AP42 Section: 12.2 Coke Production

Title: Comments and correspondence to 5th edition supplement

Re: AP-42 Comment Review and Section(s) Revision
EPA Purchase Order No. 7D-1554-NALZ
MRI Project No. 4864

RE: Changes to AP-42 Section 12.2, Coke Production

Figure 12.2-2. Flow diagram for byproduct coke production.
(Source Classification Code in parentheses.)

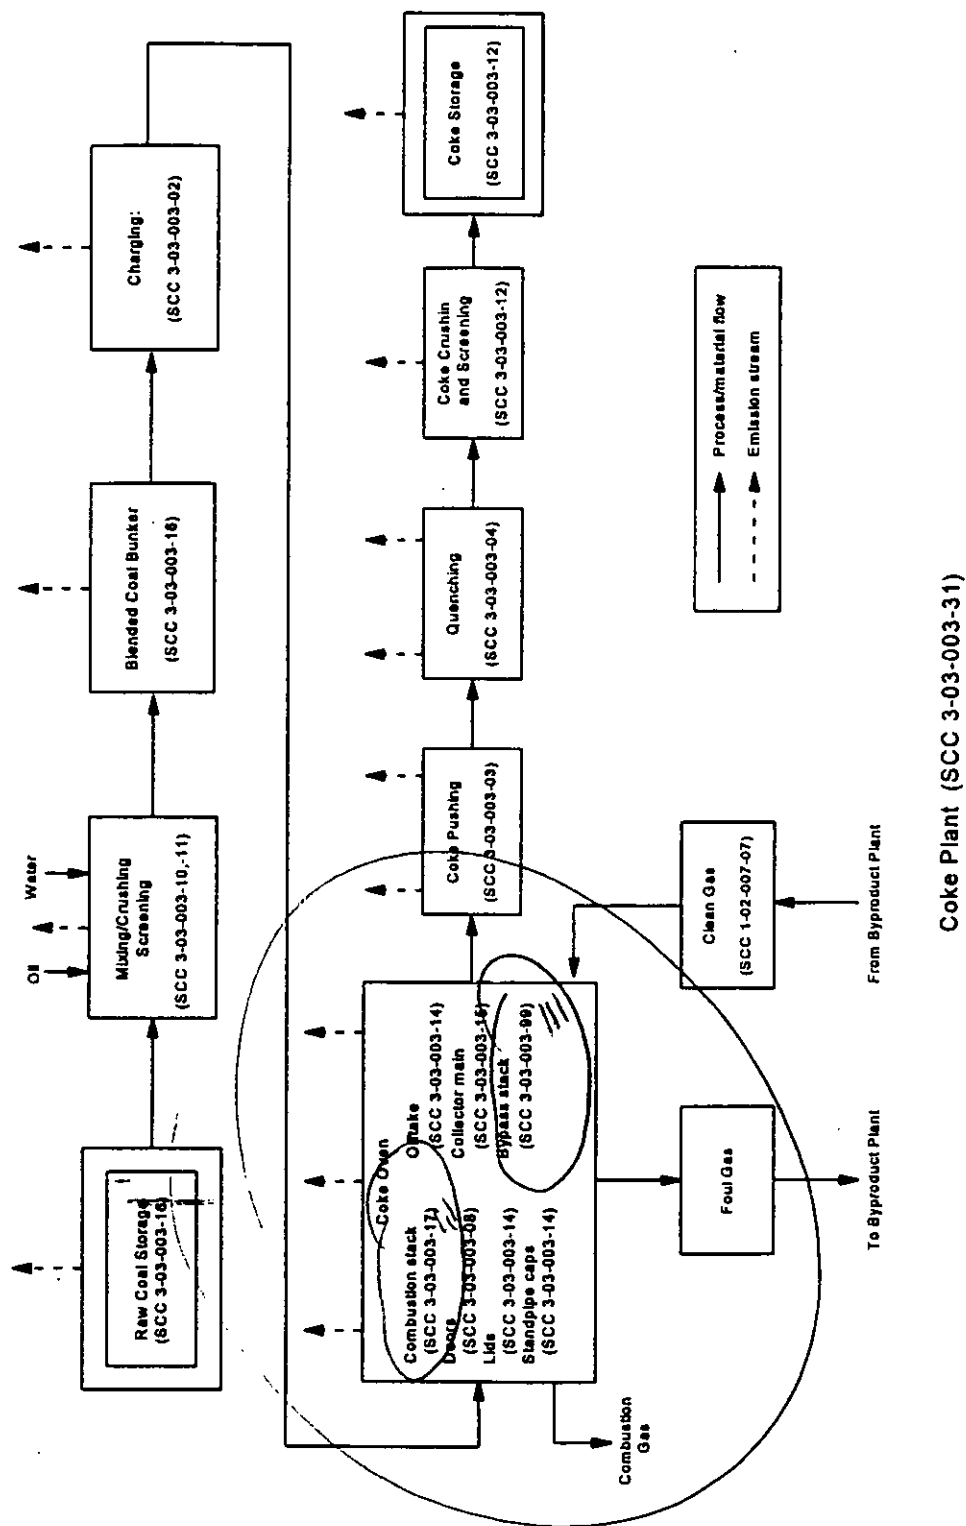
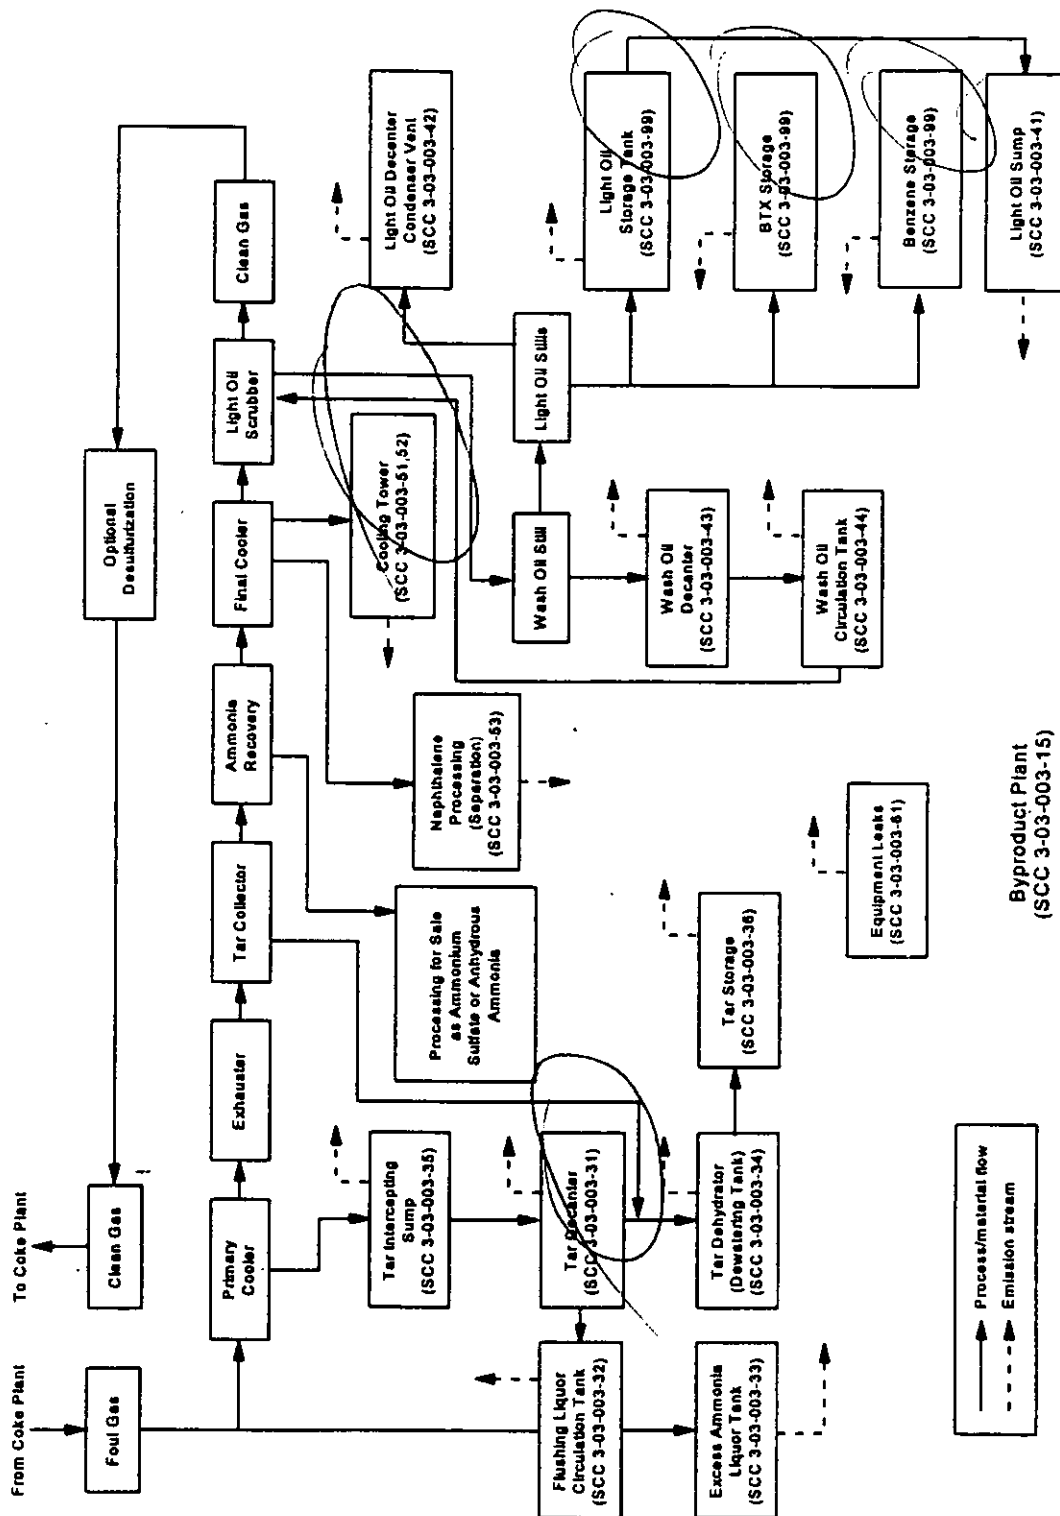
1. Figures 12.2-2 and 12.2-3. There were some blank SCC's that were completed based upon SCC's used in the AP-42 tables. Note also that the SCC for combustion stacks appeared as -06 and -17 in the text. According to Jim Turner -17 is correct and these figures were changed accordingly.

5. Table 12.2-6. Changed SCC for bypassed coke oven gas to -99; it was shown as -17 (combustion gas); this change also was made on Figure 12.2-2, which had been blank.
